Serial No. 04-318  
ESP/JDH  
Docket No. 52-008

**DOMINION NUCLEAR NORTH ANNA, LLC**  
**NORTH ANNA EARLY SITE PERMIT APPLICATION**  
**RESPONSE TO REQUEST FOR ADDITIONAL INFORMATION NO. 4**

**Response to NRC RAI Letter No. 4**

**Figure 1. Industrial Property Adjacent to the North Anna ESP Site.**

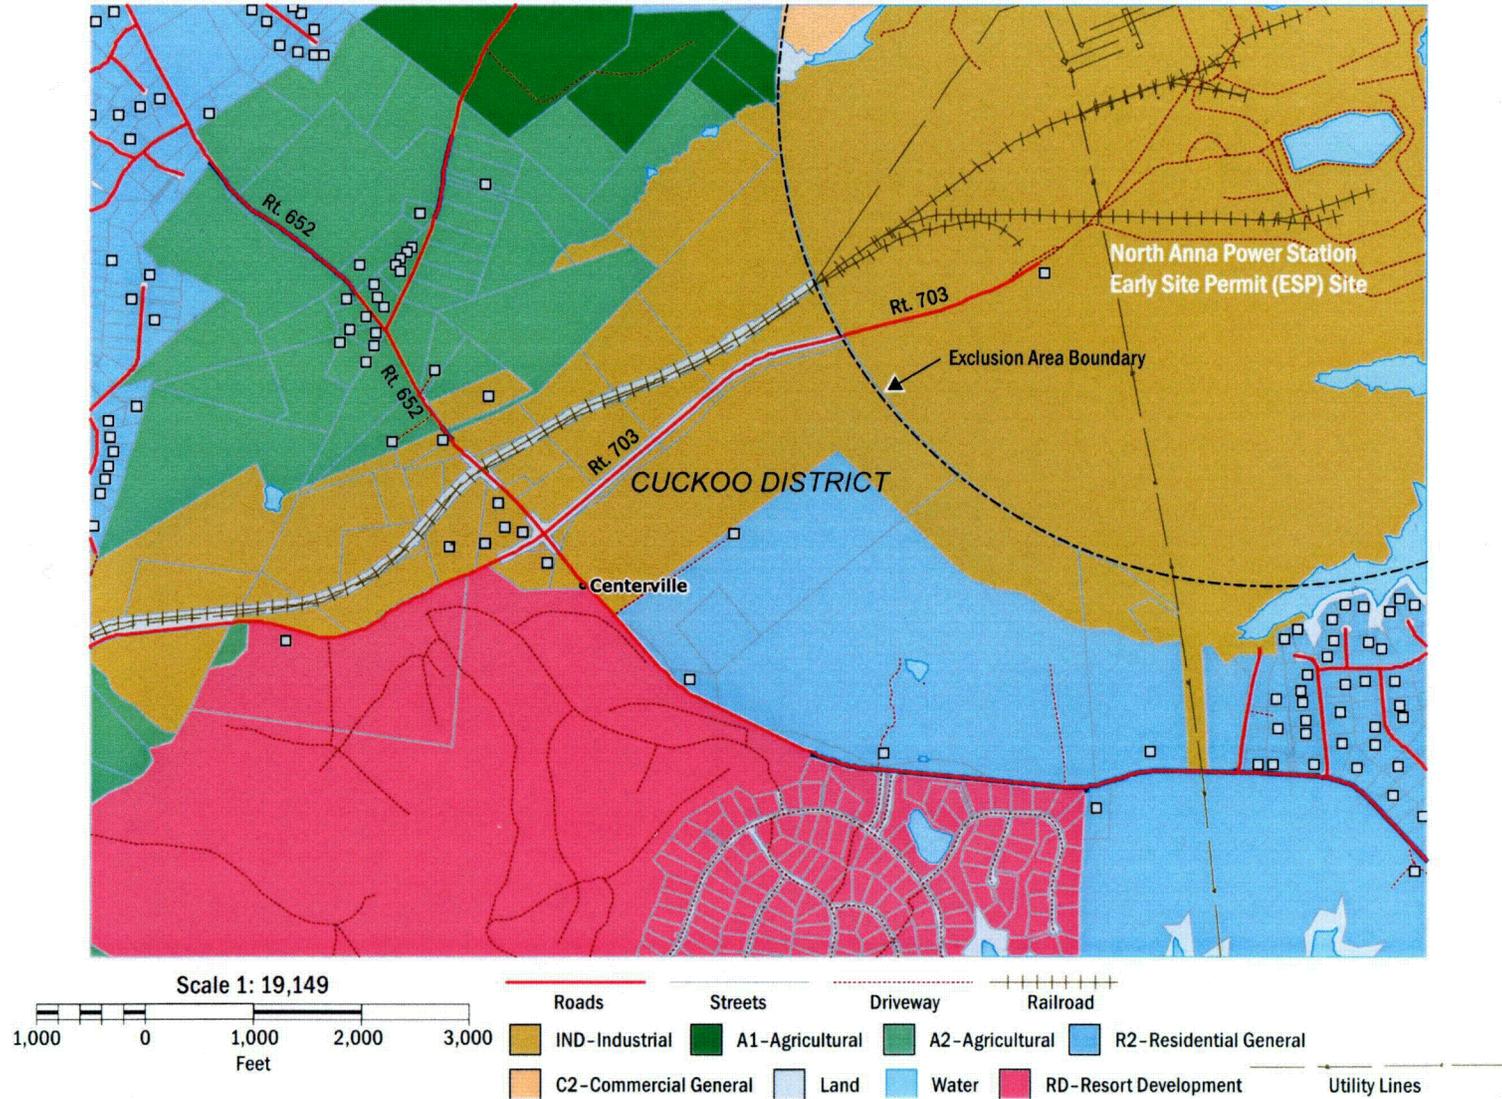
Please provide a scoping description of the nature of the industrial development (e.g., light commercial, heavy industrial) that may occur pursuant to the Louisa County Board of Supervisors zoning ordinance allowing industrial development of approximately 620 acres near the site exclusion boundary (EAB) and indicate the approximate zoned area boundary location on a map that includes the ESP site.

Reference 2 provides the website link to Louisa County's on-line GIS service. Figure 1 contains a printout from this website that shows the industrial property adjacent to the North Anna ESP site. Industrial property appears in brown on the map. The map obtained from the website (refer to map # 30 on the website) has been marked in Figure 1 to show the North Anna ESP site and the EAB.

Figure 1. Schematic Representation of North Anna Basin and Typical Unregulated Basin. (Note: The schematics do not depict actual basin sizes and shapes, but are representations of typical regulated and unregulated basins.)

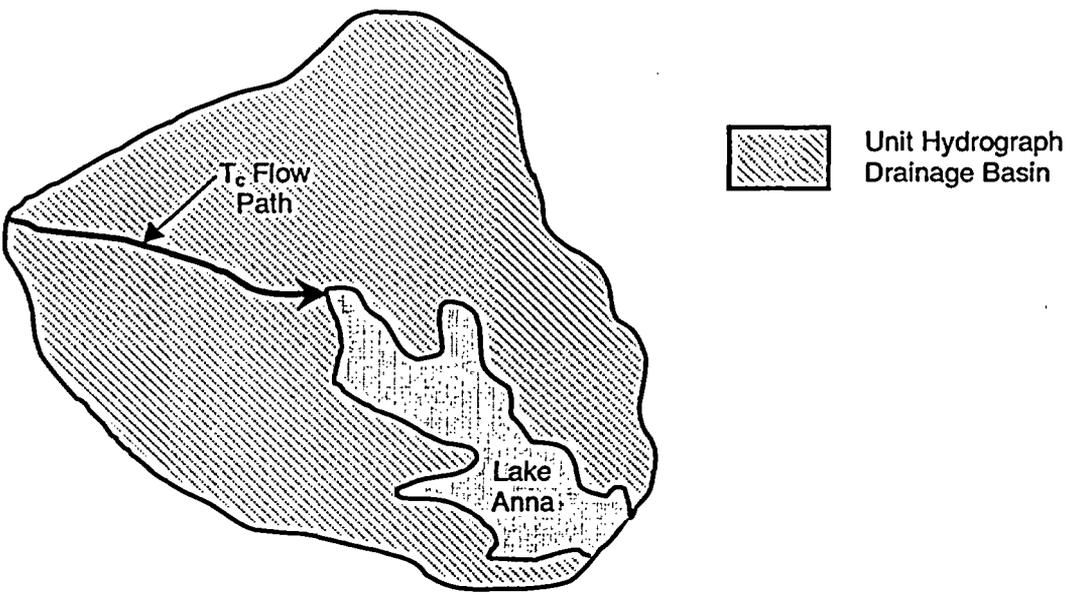
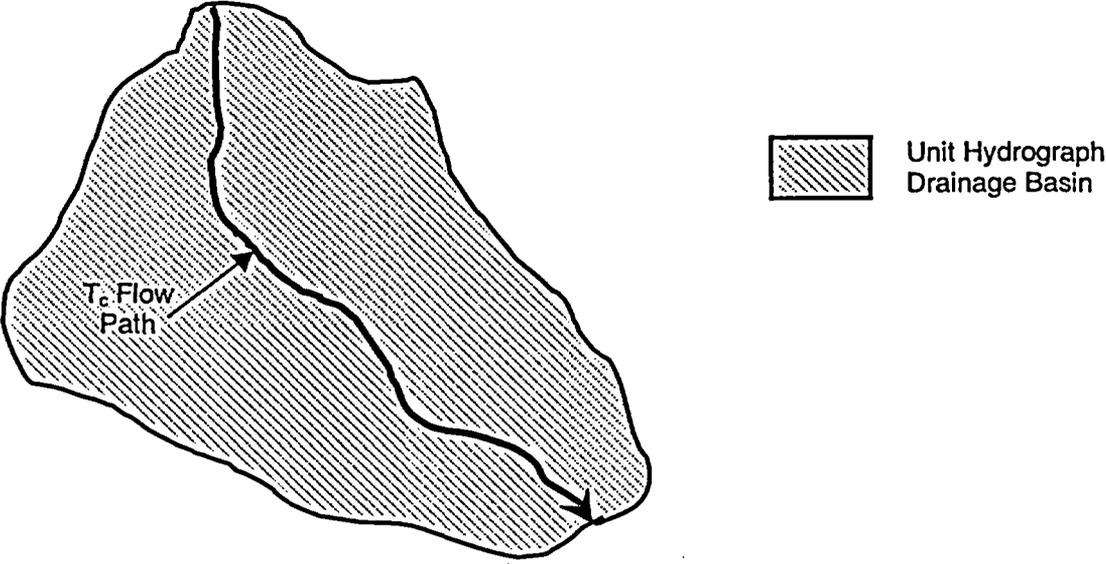
Please provide a calibrated unit hydrograph definition, expressed in terms of input parameters for the Hydrologic Engineering Center watershed modeling code (HEC-1), for an adjacent unregulated basin of size similar to the one in which the site is located, or explain why such a hydrograph is not necessary or appropriate.

The calibrated unit hydrograph used in the PMF analysis and presented in SSAR Section 2.4.3 was developed to reflect the inflow to Lake Anna and only represents the overland portion of the basin. This unit hydrograph would have a relatively short time of concentration parameter, if developed using a Clark Synthetic Unit Hydrograph as the presence of Lake Anna shortens the flow paths from all points in the basin. A separate unit hydrograph, which reflects an instantaneous response to the rainfall, is used to depict the rainfall directly over Lake Anna. The discharge hydrographs produced by these two unit hydrographs are added to determine the inflow hydrograph to Lake Anna in the runoff model.

The unit hydrograph developed for an unregulated basin of similar size and slope would have a different time of concentration than that of the inflow basin to Lake Anna. (See Figure 1 at the end of this RAI response for a schematic representation of the two basins.) Thus, the resulting unit hydrograph would also be different from the one developed for Lake Anna. The application of such a unit hydrograph for an adjacent unregulated basin to the Lake Anna basin would not be appropriate.

The unit hydrograph developed for the Lake Anna inflow was based on actual rainfall data and observed water level and discharge data measured at North Anna Dam. Because it is based on actual observed responses in the basin studied and not on correlations with nearby drainage basins, the hydrograph is more representative of the Lake Anna basin rainfall response.

Figure 2.4-15

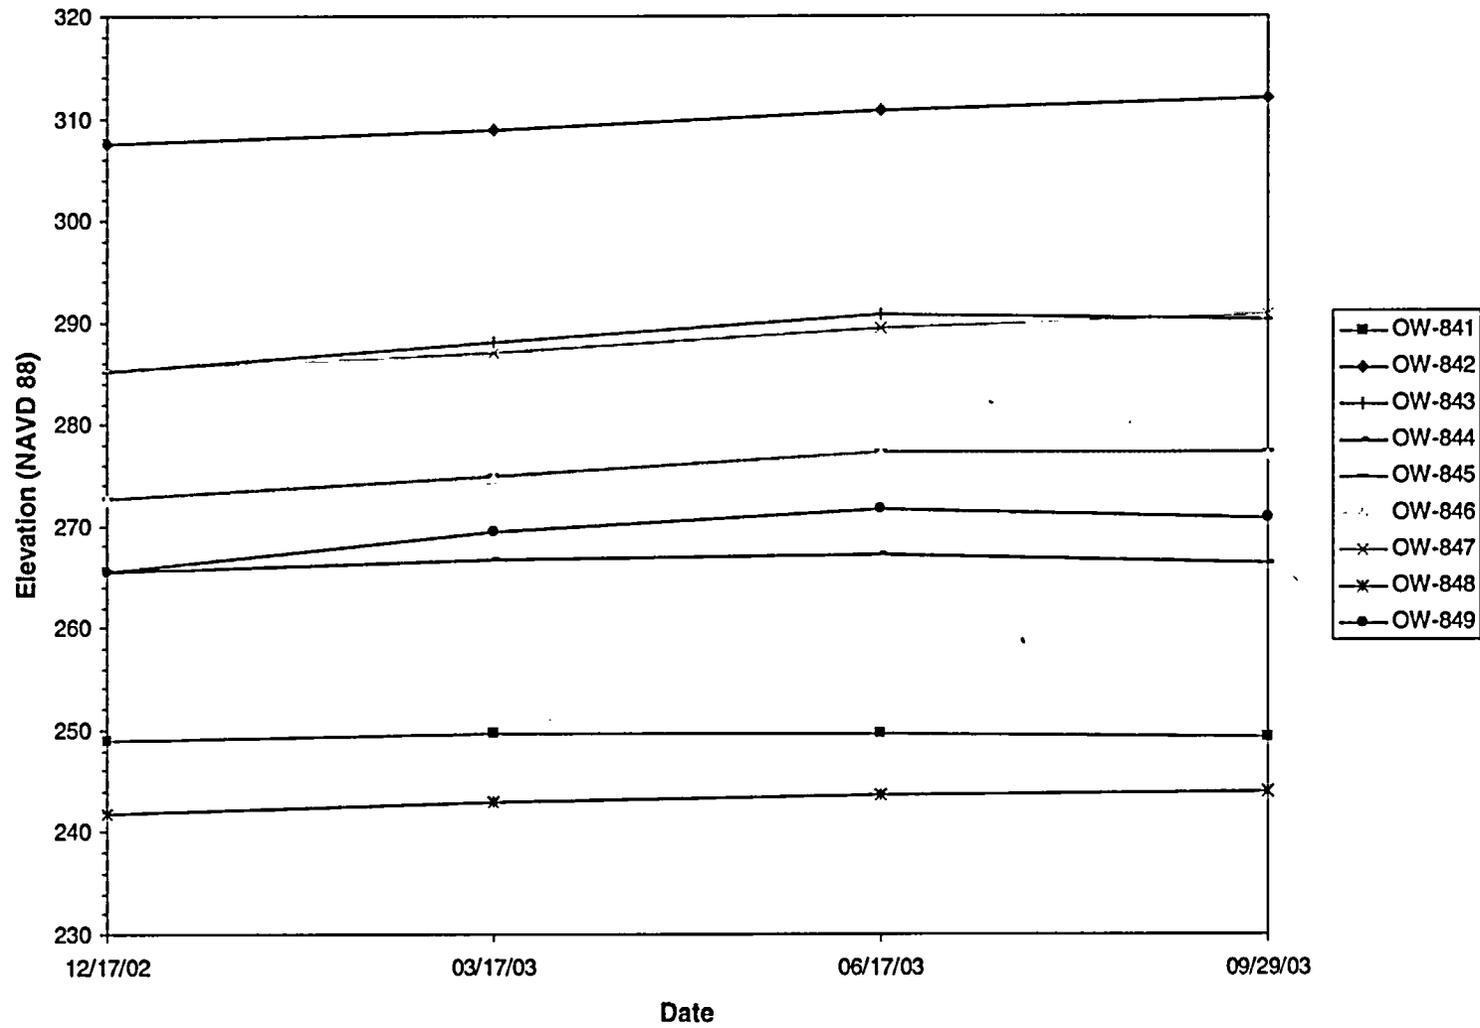
SSAR Figure 2.4-15 reports data between December 2002 and June 2003. Please update the figure with piezometer data from June 2003 to September 2003, and piezometer data prior to December 2002, if it exists, or explain how this span of data represents the seasonal variation in groundwater and how the ESP subsurface investigation program is appropriately consistent with previous groundwater measurements.

SSAR Table 2.4-15 and Figure 2.4-15 will be updated to include the fourth round of groundwater level measurements taken at the North Anna site on September 29, 2003.

SSAR Table 2.4-15 and Figure 2.4-15 will be replaced with the revised versions shown on the next 2 pages.
